## Addendum No. 2

DATE:	Monday, June 24, 2019
PROJECT:	City of Pharr/PSJA Aquatic Facility
PROJECT NO:	971805/ 1819-35-510-C011-051
LOCATION:	3001 N. Cage Blvd., Pharr, Texas 78577
FROM:	Laura N. Warren, The Warren Group Architects, Inc.

A3.02 ADD2 BUILDING SECTIONS

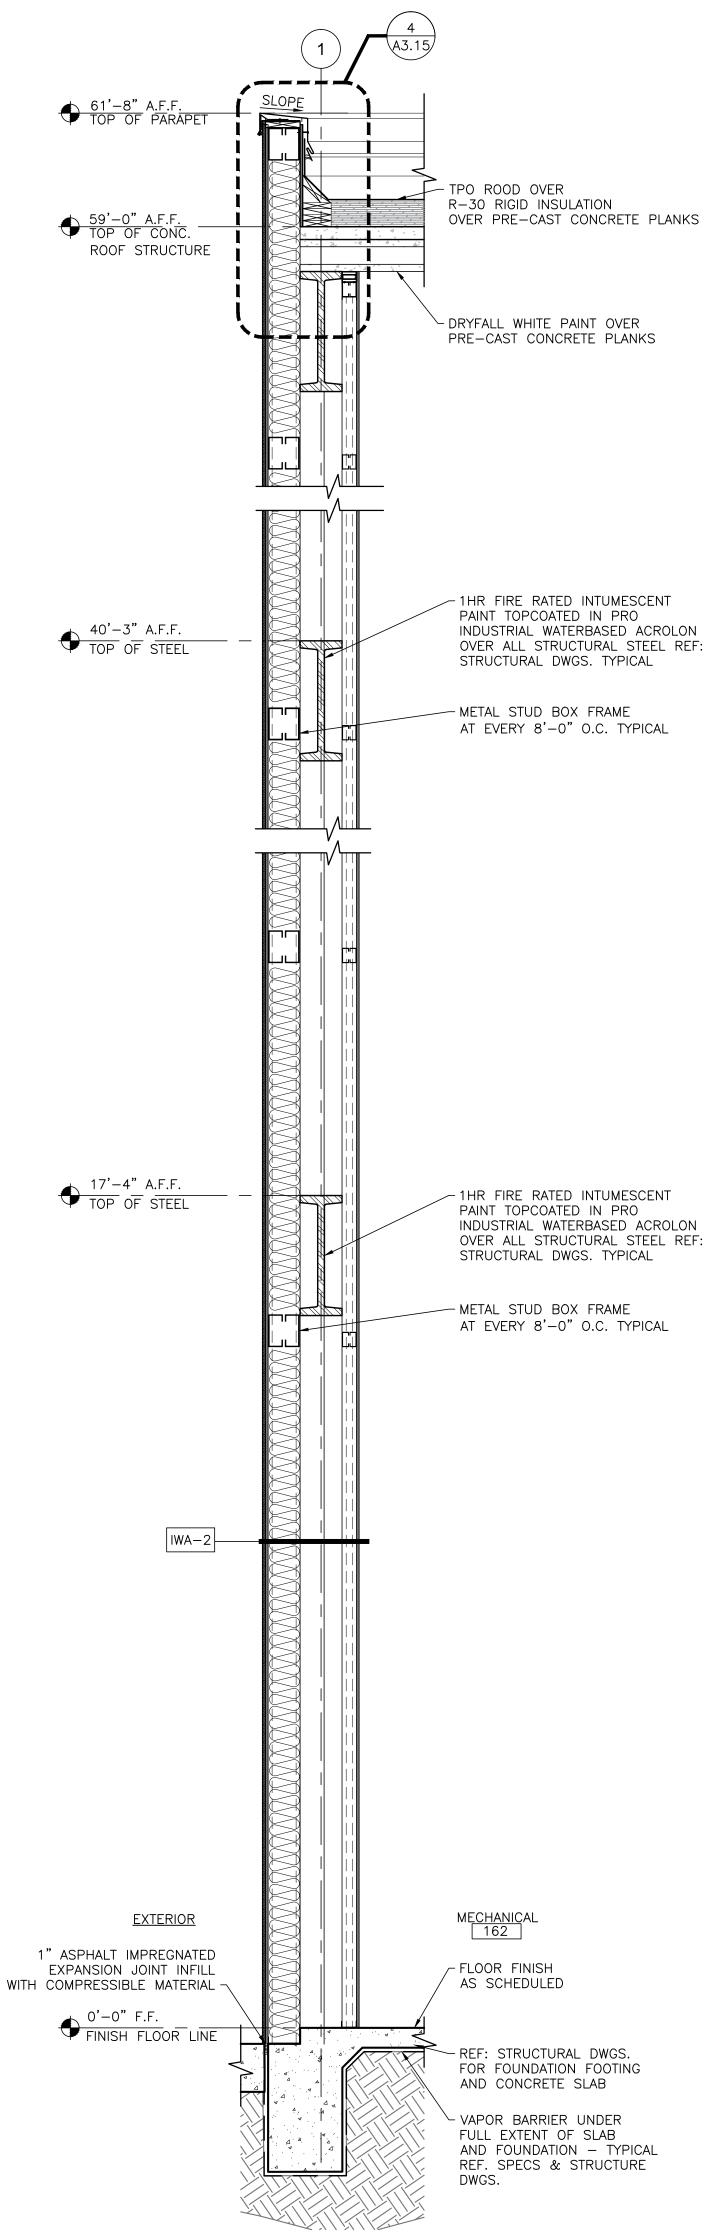
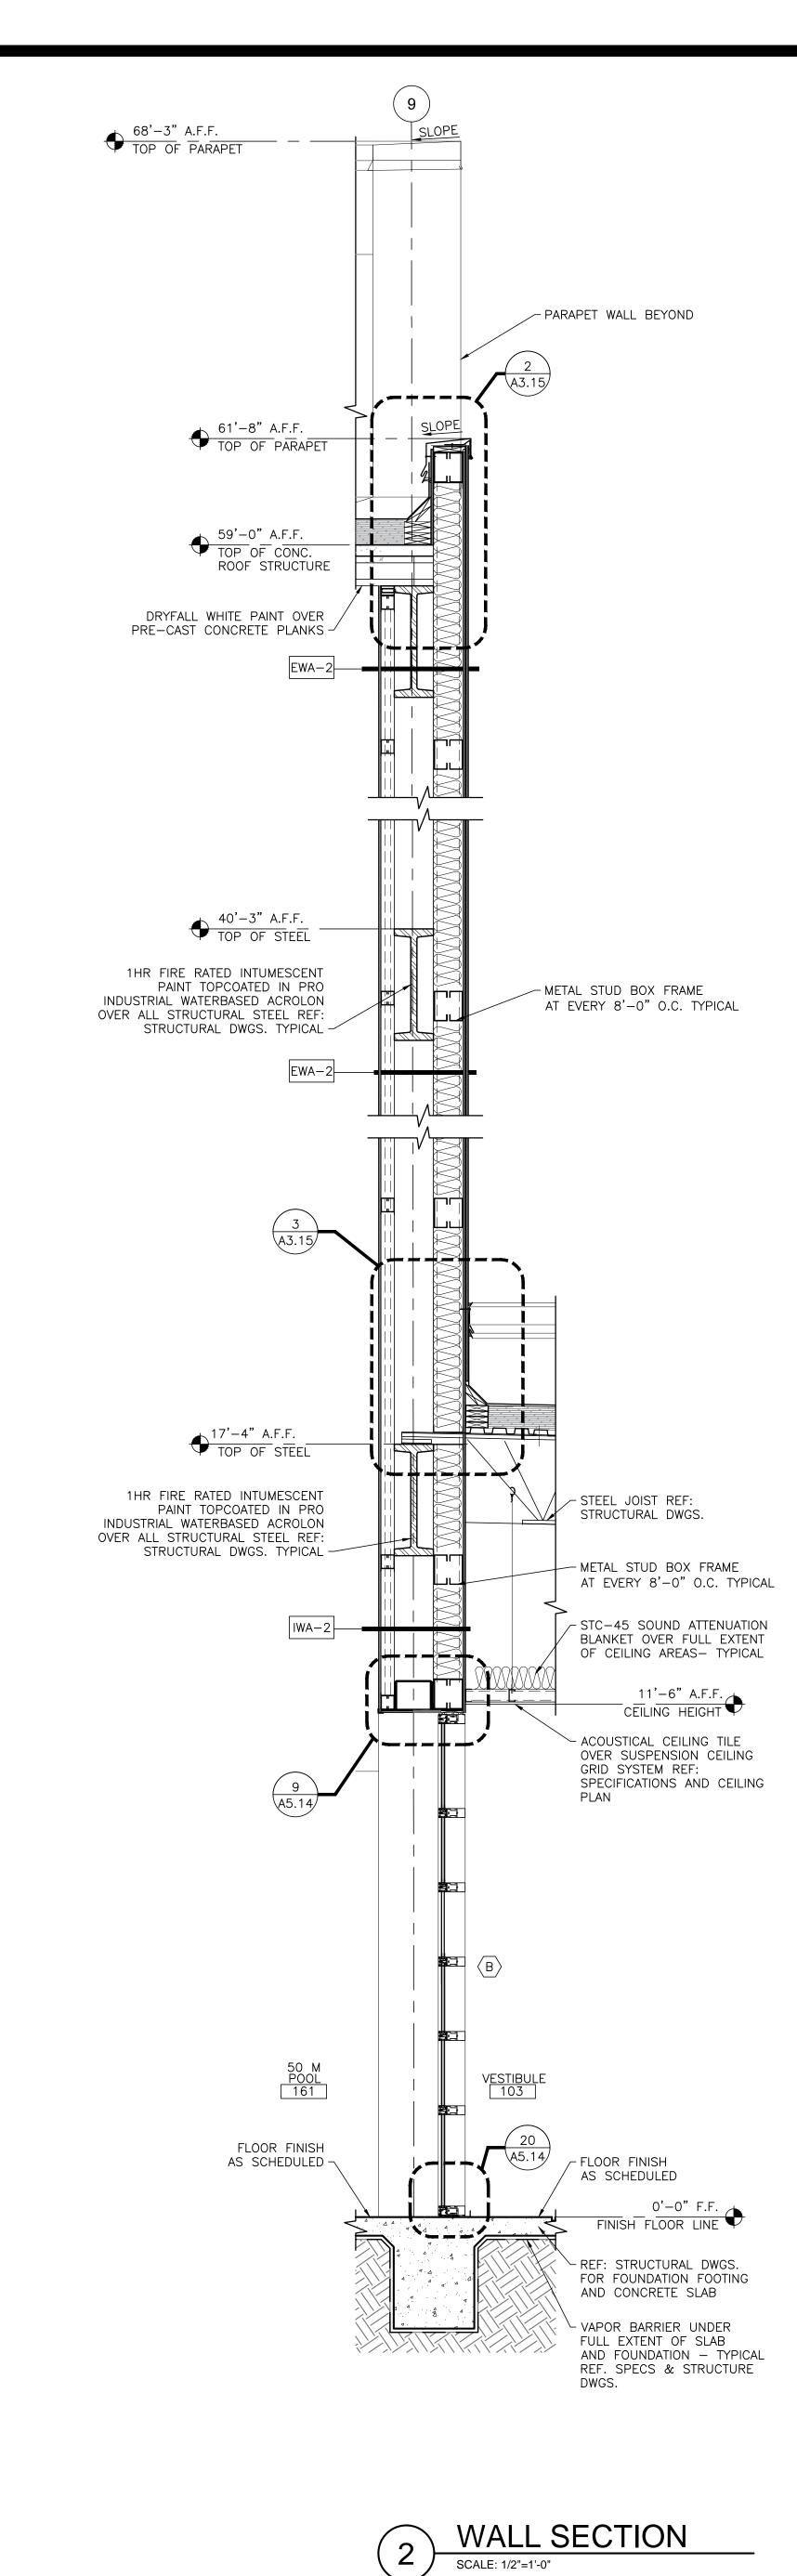
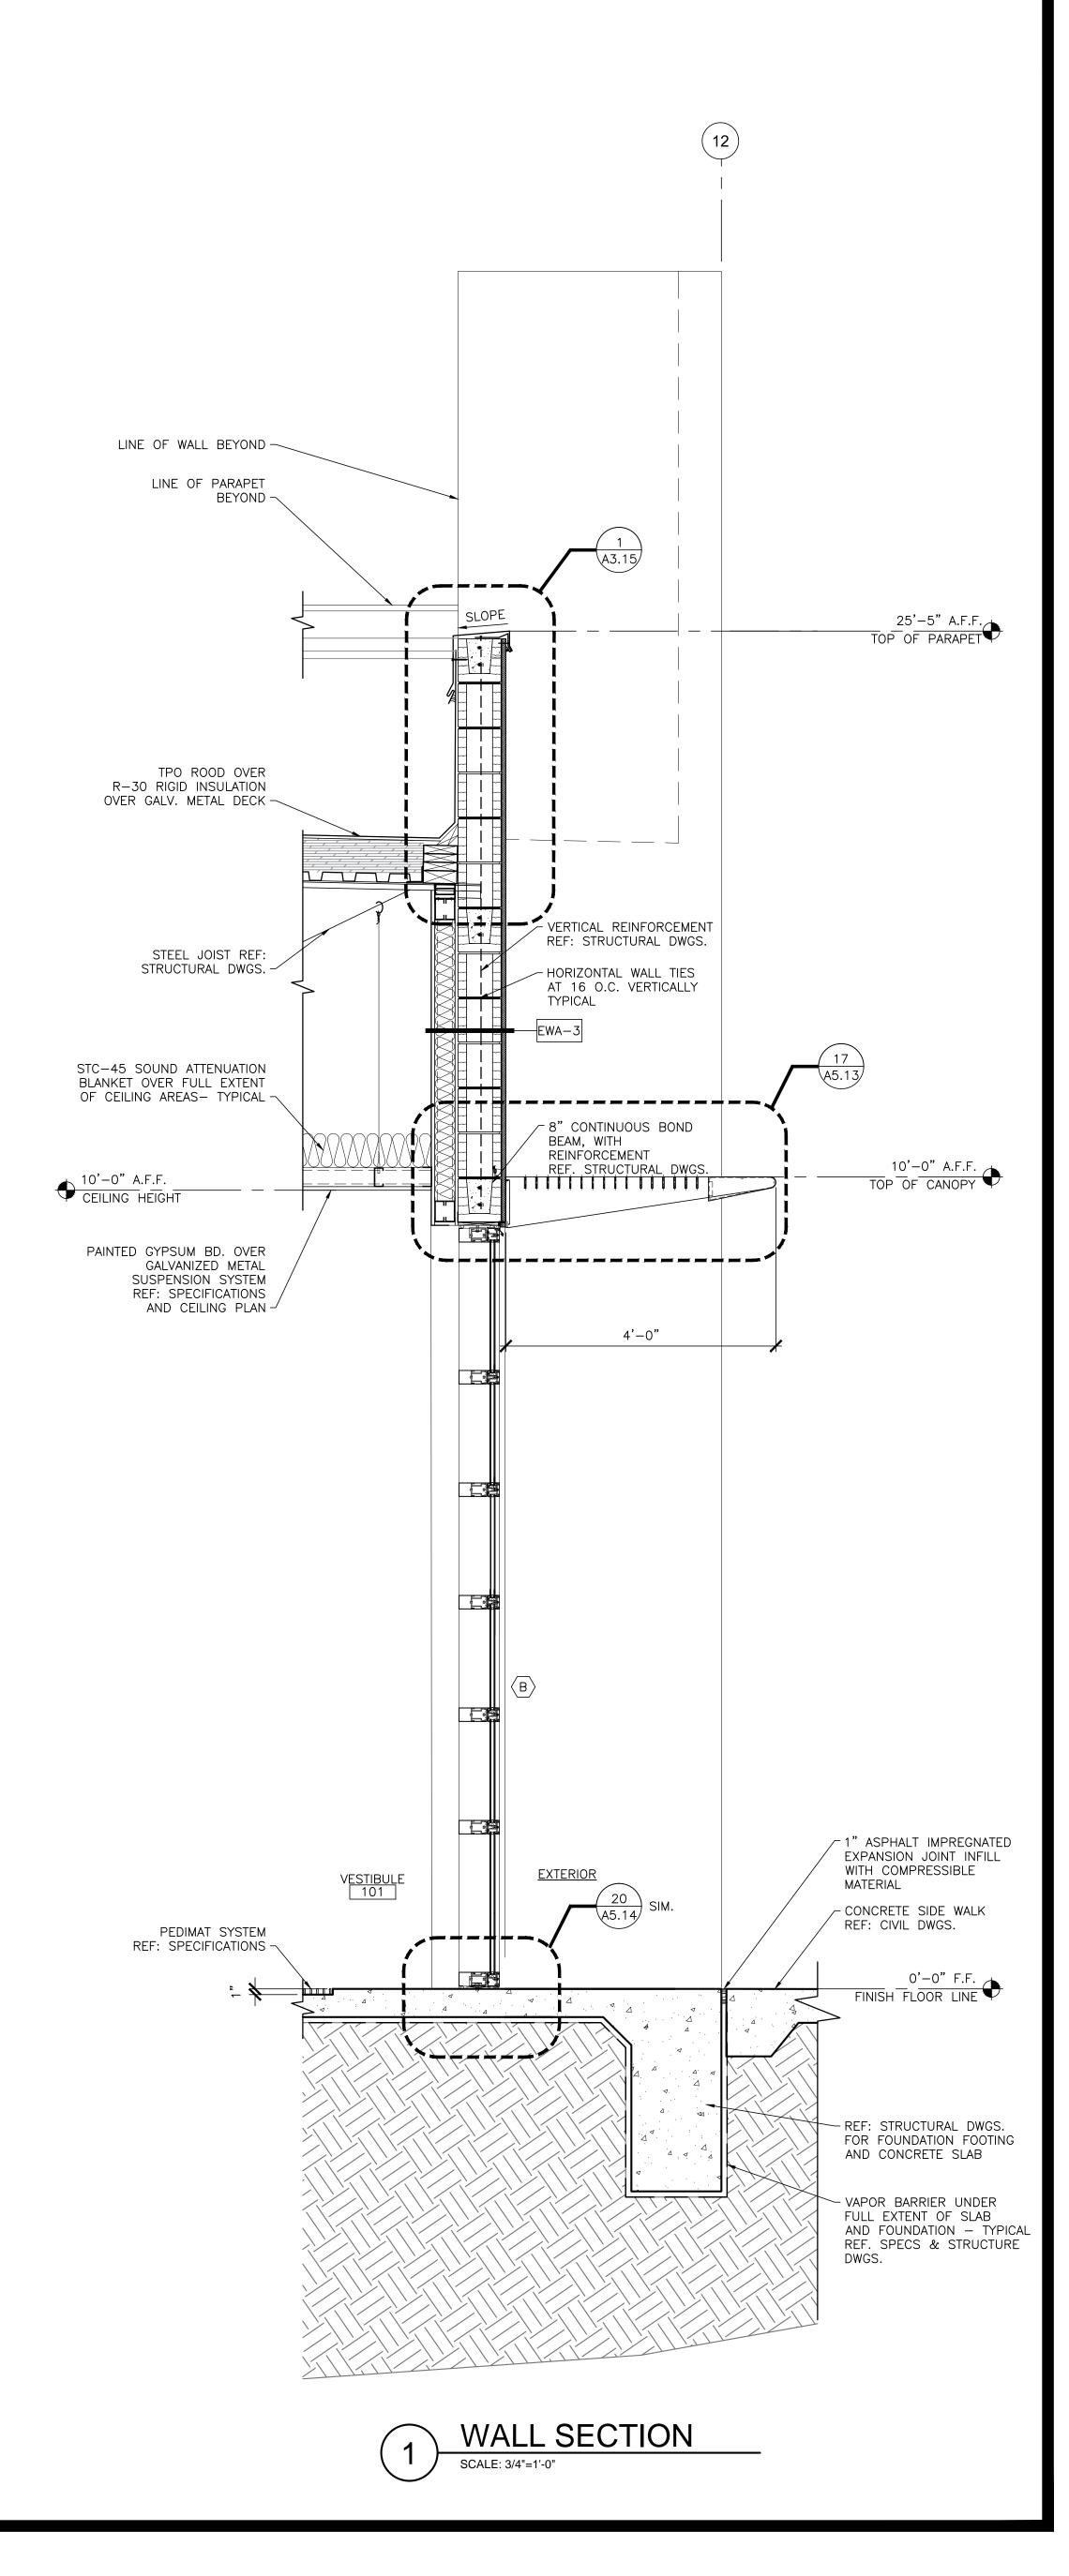
- Item No. 24: Refer to Construction Documents dated June 7, 2019. Section detail has been referenced. Refer to 30x42 sheet A3.02 ADD2 dated 6/21/2019.

A3.15ADD2

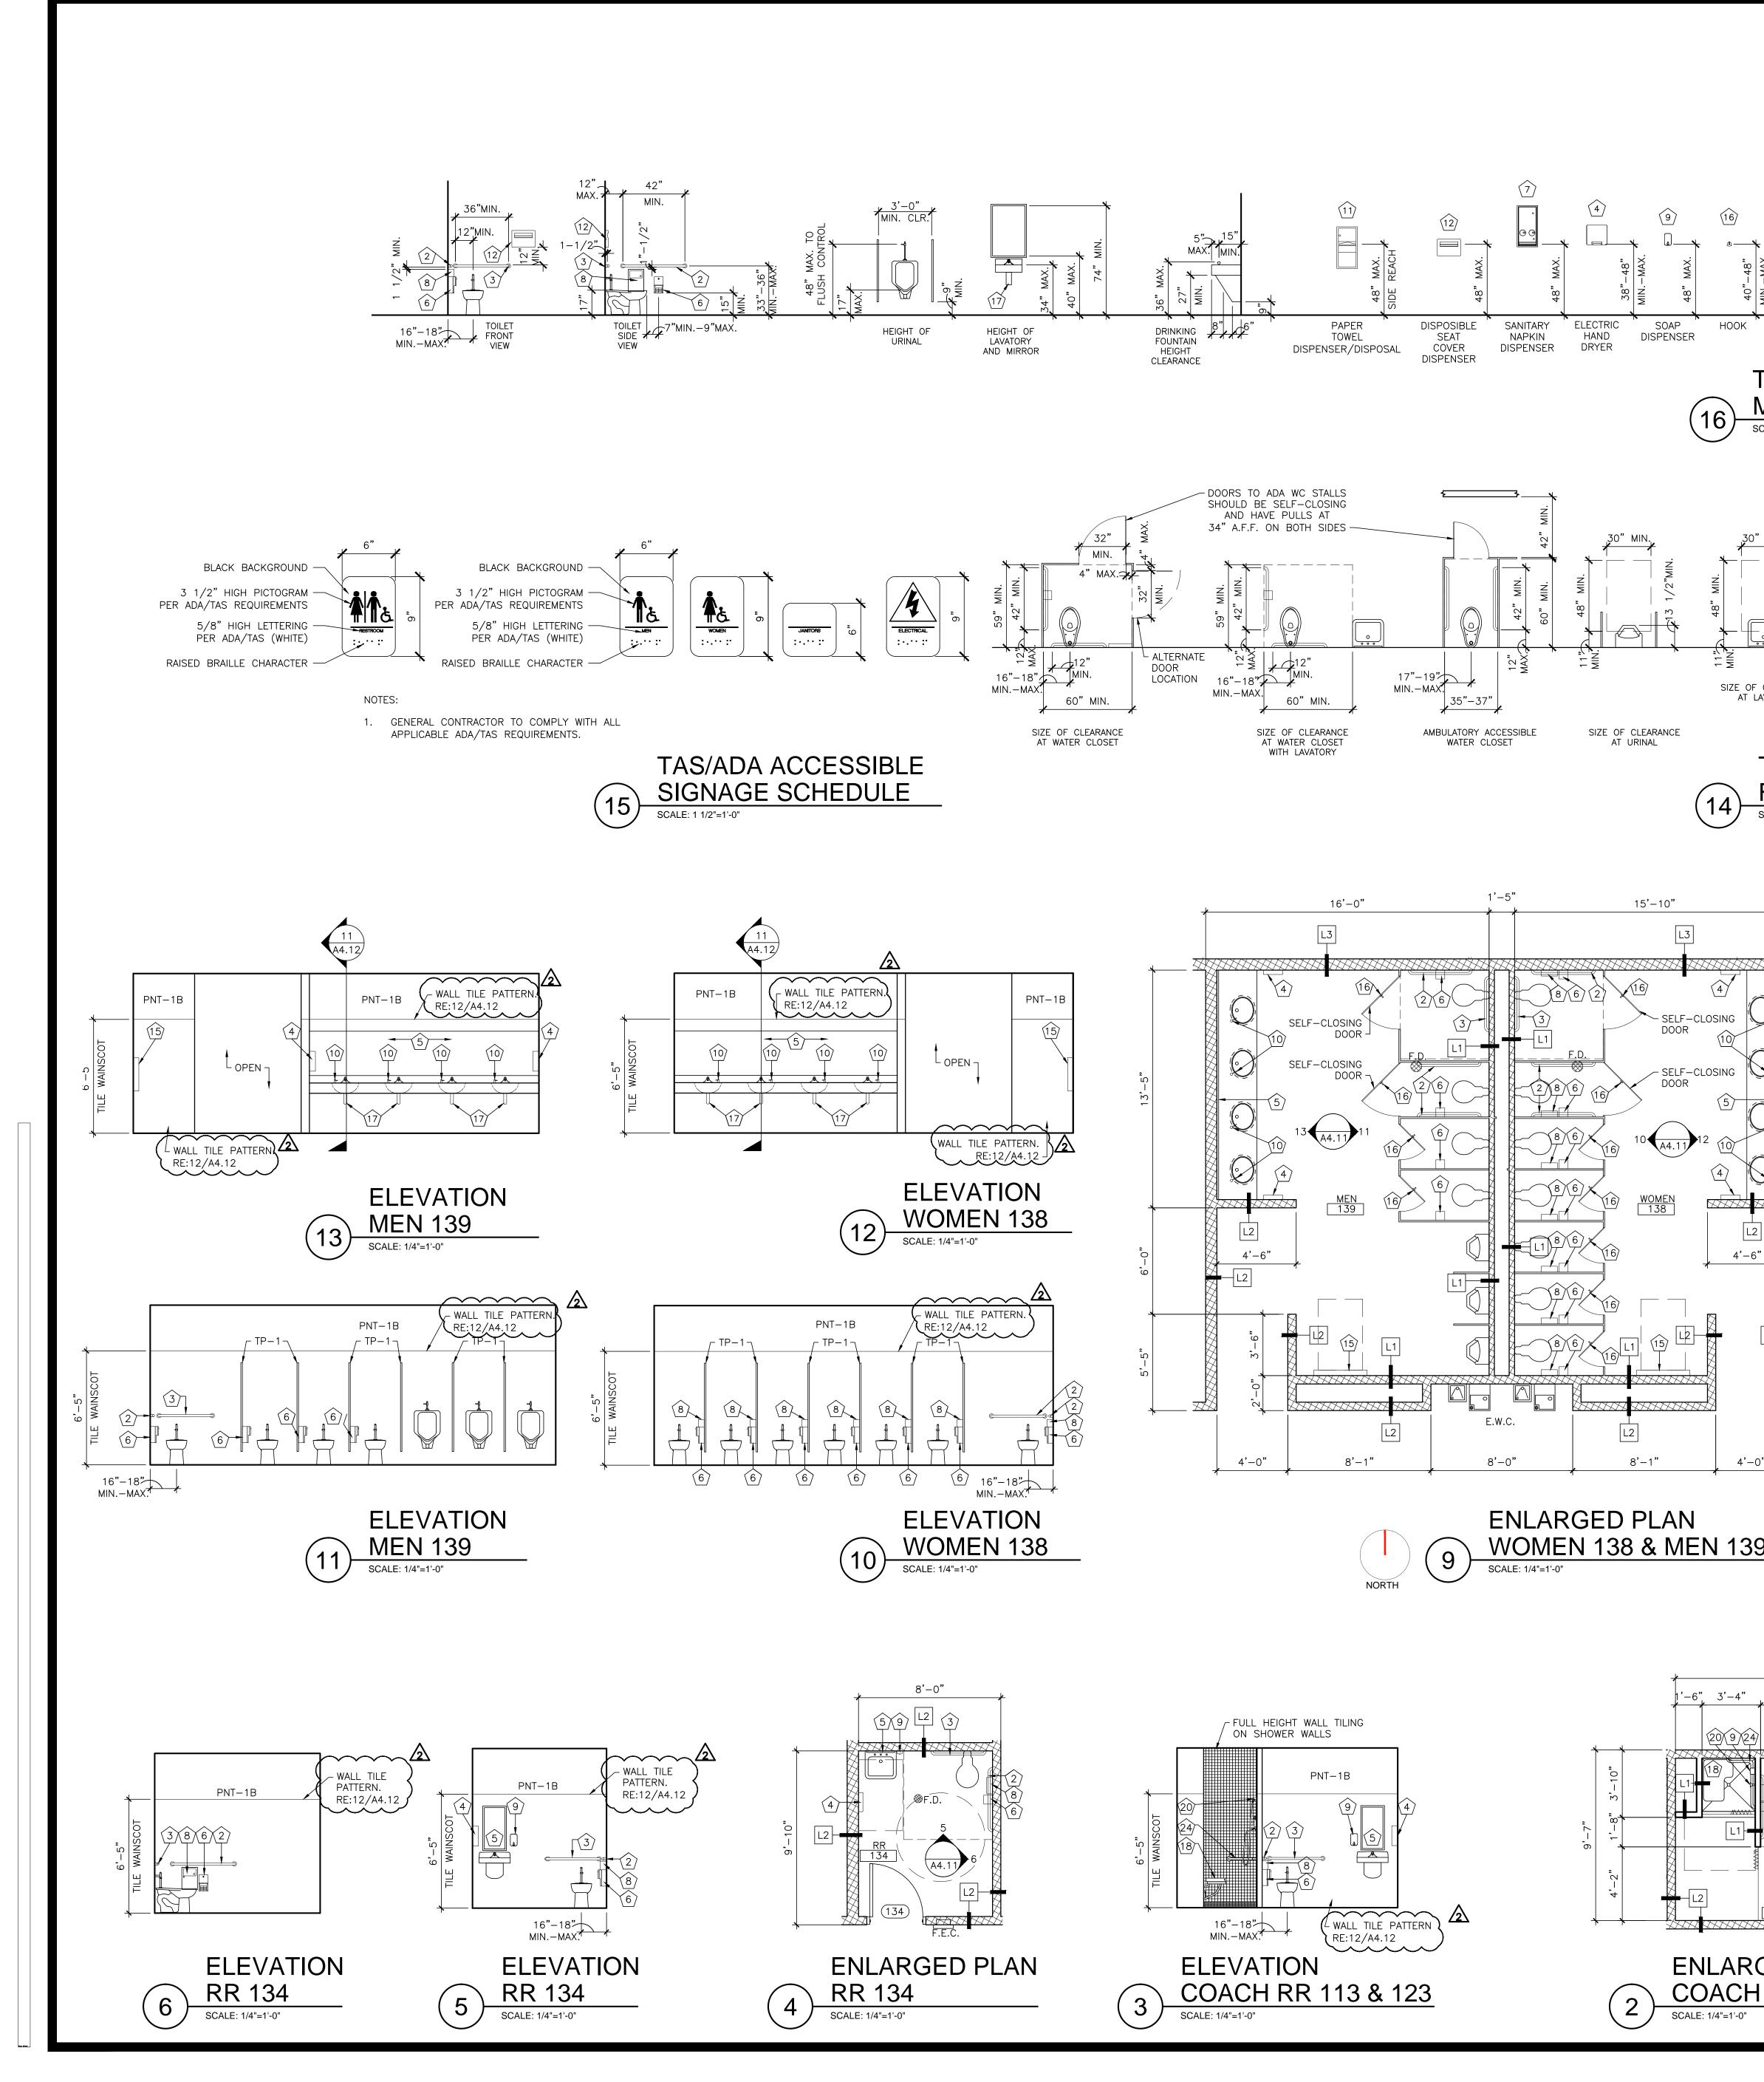
- Item No. 26: Refer to Construction Documents dated June 7, 2019. Parapet details have been provided. Refer to 30x42 sheet A3.15 ADD2 dated 6/21/2019.
